Westinghouse
Electric Corporation

CAW-84-78
August 7, 1984

APPLICATION FOR WITHHOLDING PROPRIETARY
INFORMATION FROM PUBLIC DISCLOSURE

ENCLOSURE 2

FIGURE 14.1.2-7
 ROD WITHDRAWAL AT POWER 10 PERCENT POWER
 MINIMUM DNBR VS REACTIVITY INSERTION RATE

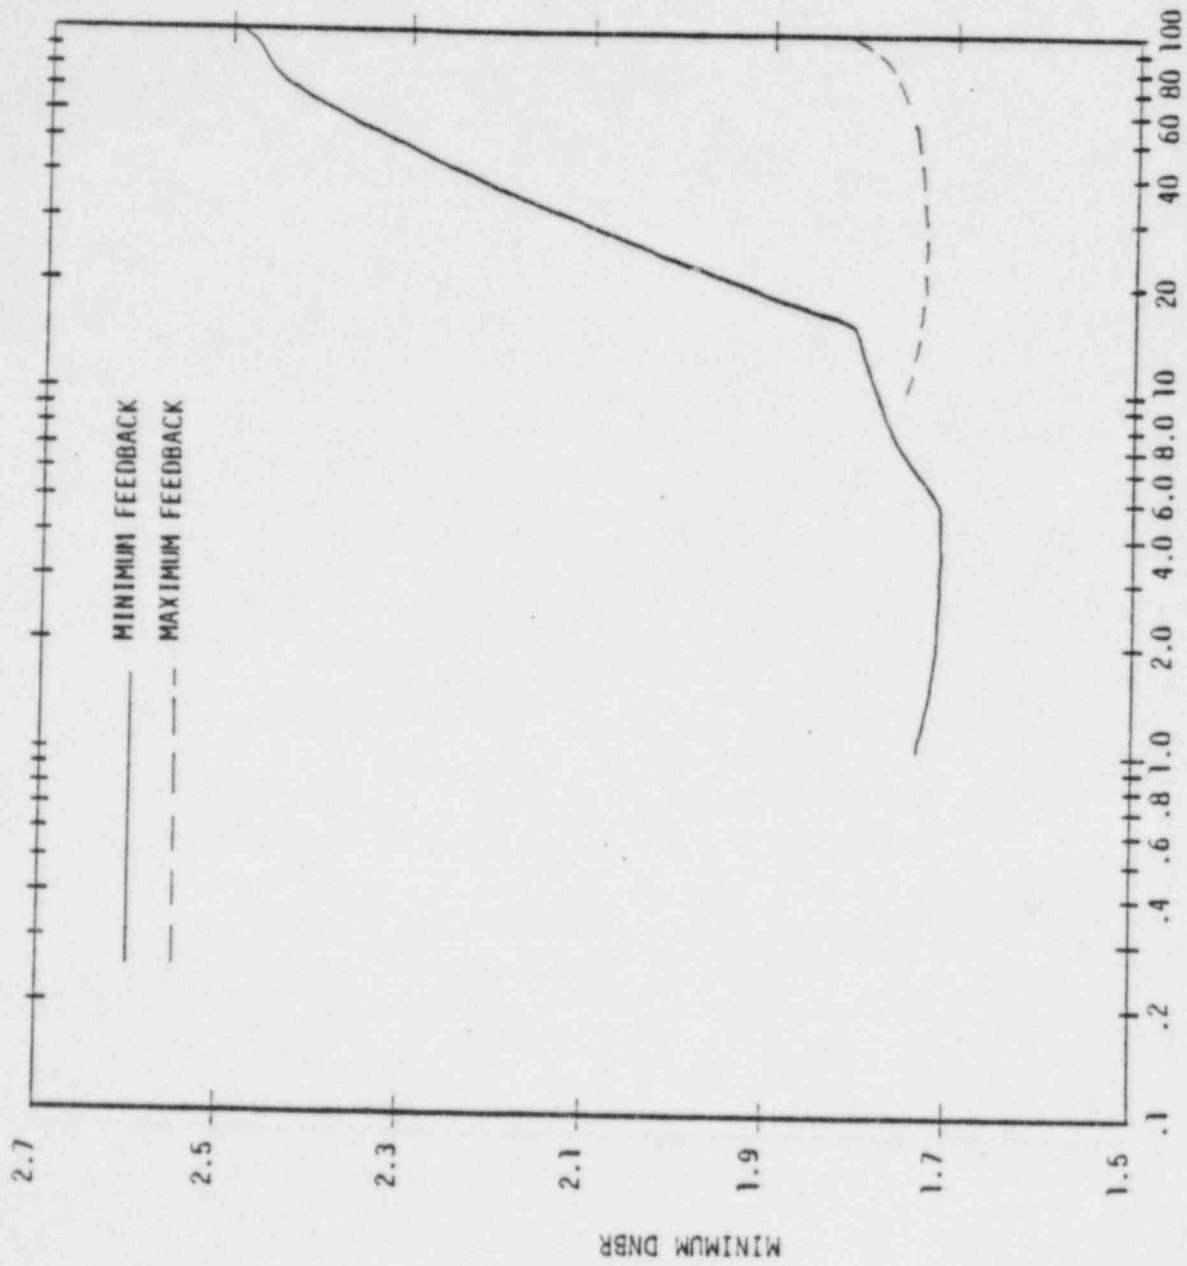
Please identify the limiting DNBR transient and provide the results of the analysis of the event, including the calculated value of minimum DNBR.

The limiting DNB transient is Uncontrolled RCCA Withdrawal at Power. Results of this postulated event, including figures of the minimum calculated values of DNBR, are attached.

Figures 14.1.2-1 and 14.1.2-2 show the response of neutron flux, pressure, average coolant temperature, and departure from nucleate boiling

The response of neutron flux, pressure, average coolant temperature, and DNBR for a slow control rod assembly withdrawal from 10% power is shown in Figures 14.1.2-3 and 14.1.2-4. Reactor trip on overtemperature ΔT occurs after a longer period, and the rise in temperature and pressure is consequently larger than for rapid rod cluster control assembly withdrawal. Again, the minimum DNBR is greater than the limit value.

Figure 14.1.2-5 shows the minimum departure from nucleate boiling ratio as a function of reactivity insertion rate from initial full-power operation for the minimum and maximum reactivity feedback cases. It can be seen that two reactor trip channels provide protection over the whole range of reactivity insertion rates. These are the high neutron flux and overtemperature ΔT trip channels. The minimum DNBR is never less than the limit value.

Figures 14.1.2-6 and 14.1.2-7 show the minimum departure from nucleate boiling ratio as a function of reactivity insertion rate for rod cluster control assembly withdrawal incidents starting at 60% and 10% power respectively. The results are similar to the 100% power case, except that as the initial power is decreased, the range over which the overtemperature ΔT trip is effective is increased. In neither case does the departure from nucleate boiling ratio fall below the DNBR limit value.

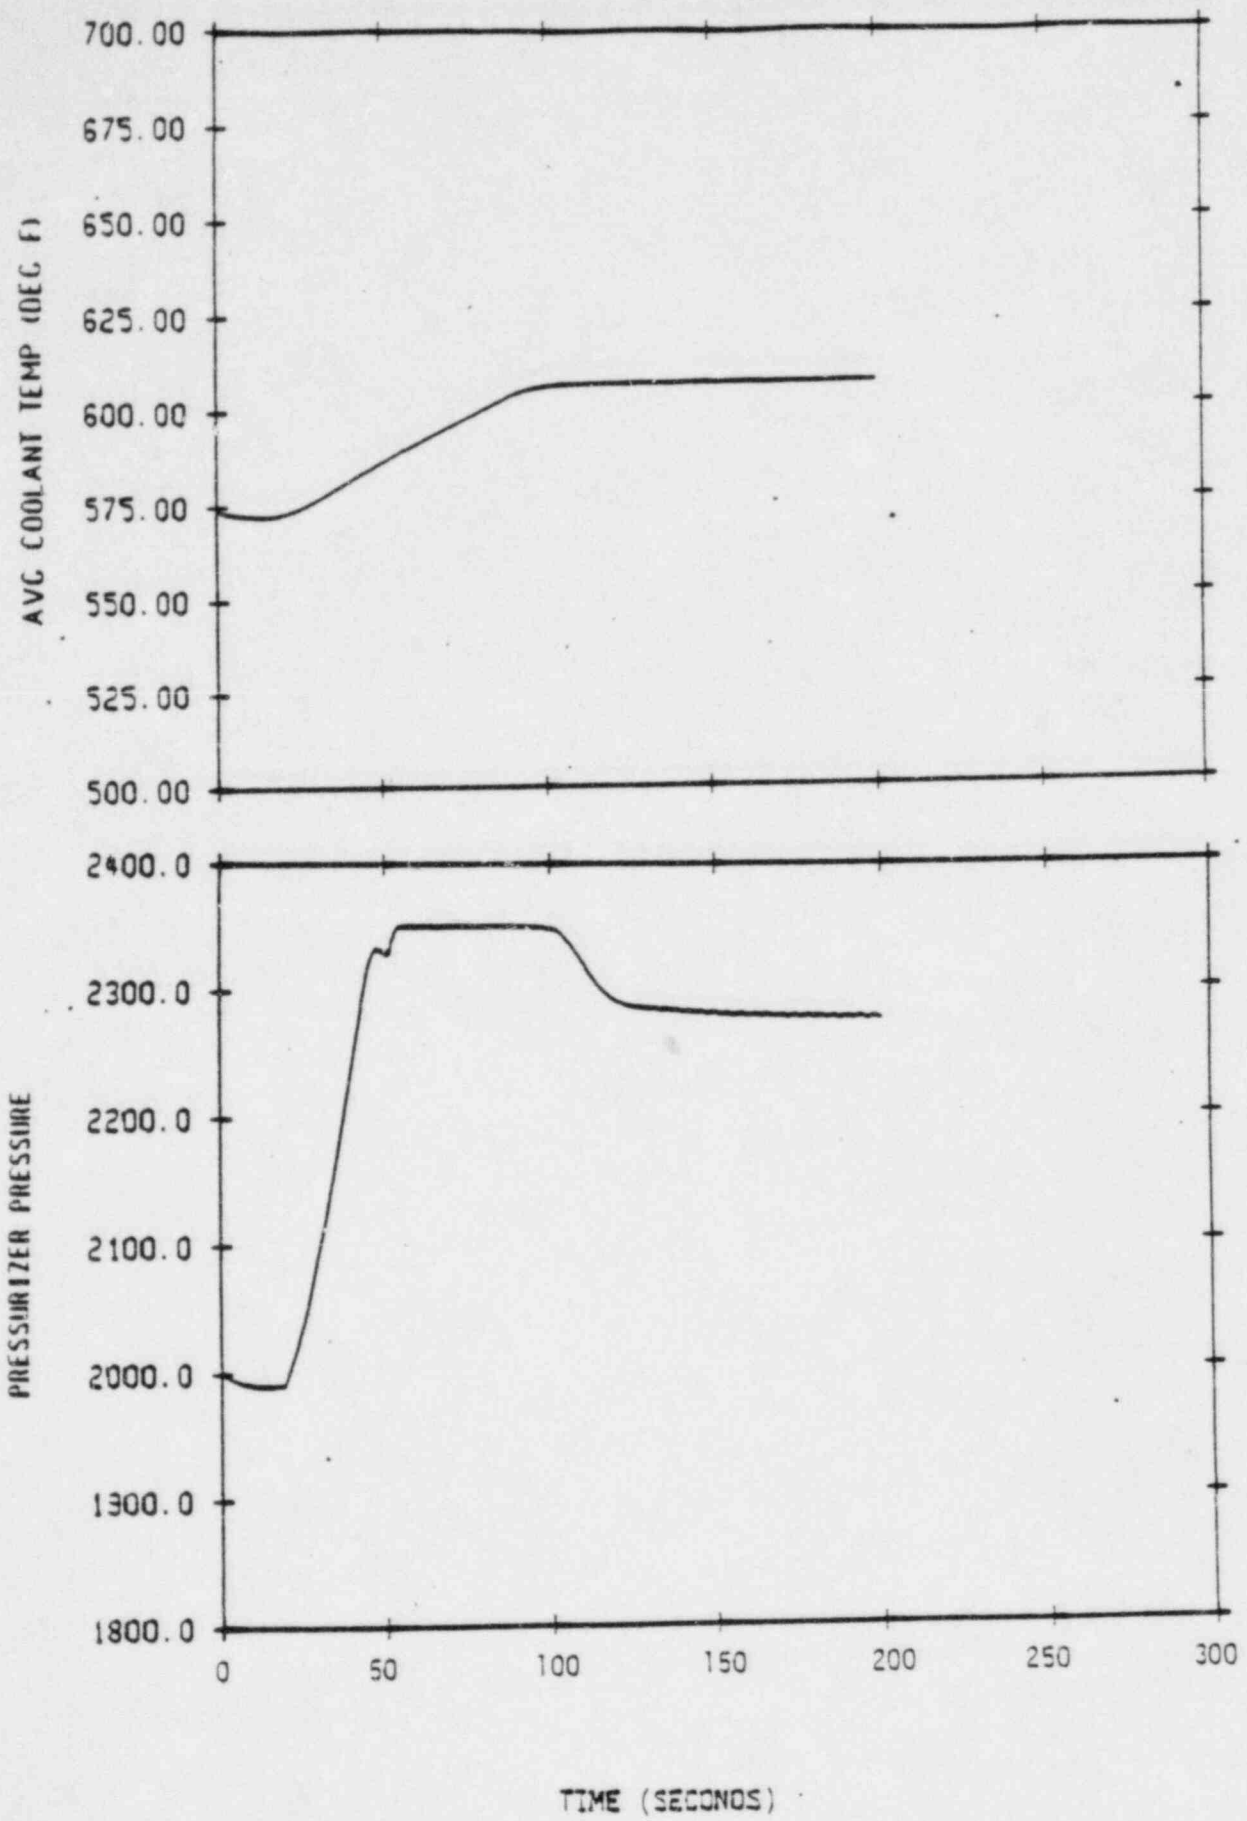
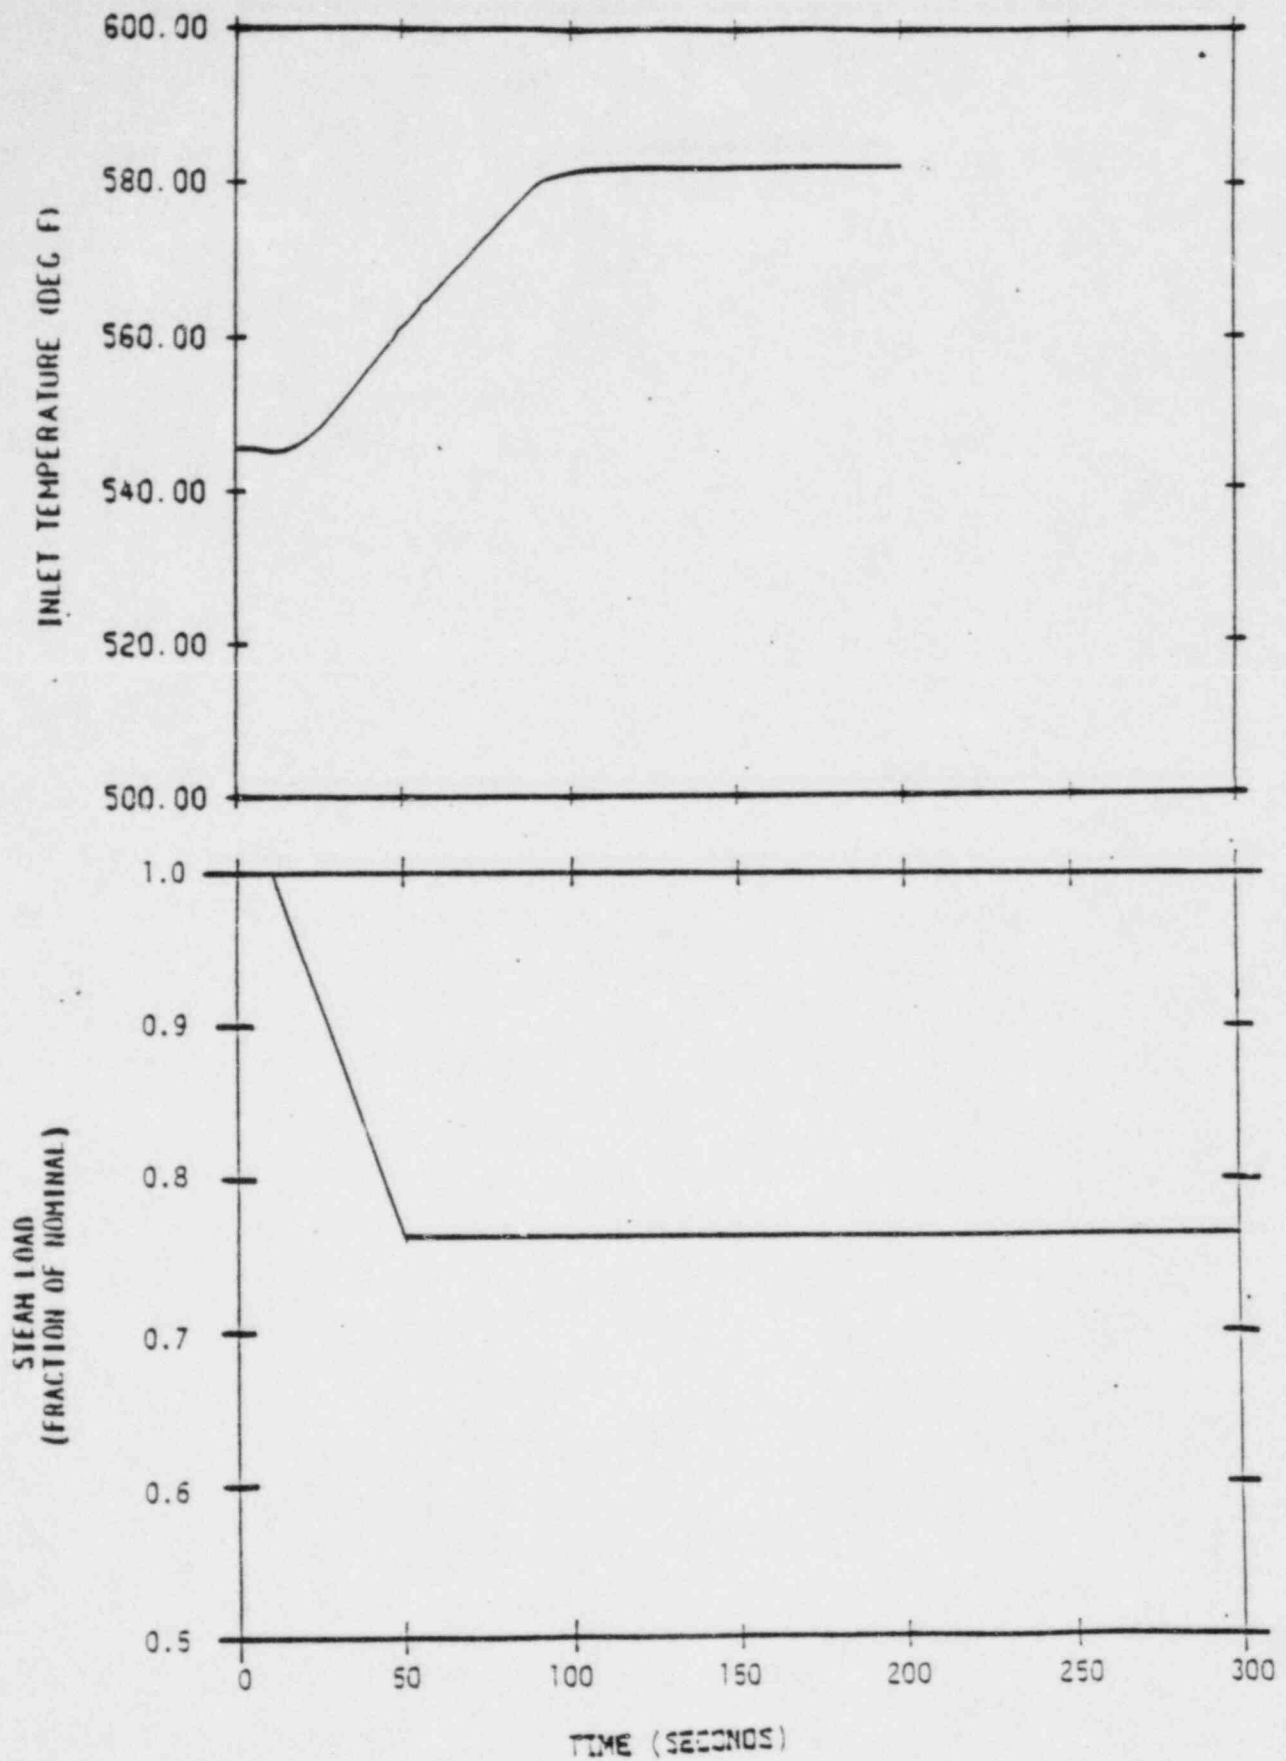
Westinghouse has recognized that, under certain circumstances, the FSAR analysis of the dropped rod event for turbine runback plants may not be complete. Specifically dropping a very low worth rod would lead to a turbine runback to 78 percent power but would not reduce core power by this amount. Thus a core turbine mismatch would be created with possible violation of DNBR limits. Please confirm that an analysis of this scenario has been performed, describe the analysis procedure, and provide the results for the limiting core configuration.

Figures 14.1.3-4 through 14.1.3-6 illustrate the transient response following a dropped rod of worth 75 pcm. The reactor coolant average temperature decreases initially, due to the decrease in reactor core power. Since the drop in power is less than the drop in load, with no reactivity feedback, coolant temperature then increases. The higher primary power level (as opposed to secondary) is eventually matched by opening of the steam generator safety valves. Steady-state conditions are then achieved.
